ADDENDUM #3

**Re: I-440, Widening from I-40 to I-24
Davidson County
Contract No. DB1701**

This addendum revises the RFP Contract Book 1,2, and 3. Also, this addendum revises SP108B, SP725 – ITS, SP718NB, and adds SP716DB – Contrast Striping. Attached are the revised sheets.

SPECIAL PROVISION 716DB

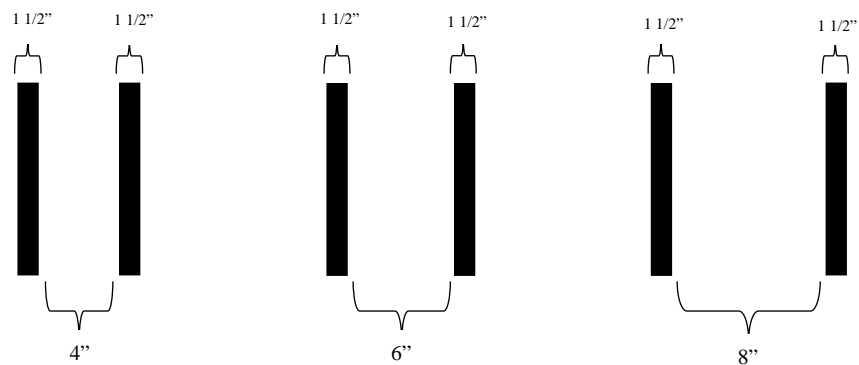
This specification covers the requirements for placement of a Contrast Pavement Marking system on portland cement concrete pavements and bridge decks.

Provide black, white and yellow Thermoplastic Pavement Marking Material meeting the requirements of subsection 919.02, Spray Thermoplastic Pavement Marking Material, of the TDOT Standard Specifications. All material shall be matching systems from the same supplier.

As an Alternate to spray thermoplastic marking material, provide a product from the TDOT Qualified Products List (QPL)

Apply the contrast pavement markings in accordance with section 716.03 and 919.02 of the TDOT Standard Specifications, with the following changes.

- Ensure the pavement temperature is a minimum of 40°F and rising before beginning application and suspend operations if the temperature of the pavement falls below 40°F.
- Apply the black thermoplastic material at a rate of 40 mils followed by either the white or yellow thermoplastic material at a rate of 60 mils for a total thickness of 100 mils.
- If an Alternate product is selected, apply in accordance with section 716.06 of the TDOT Specifications and the manufactures recommendations.
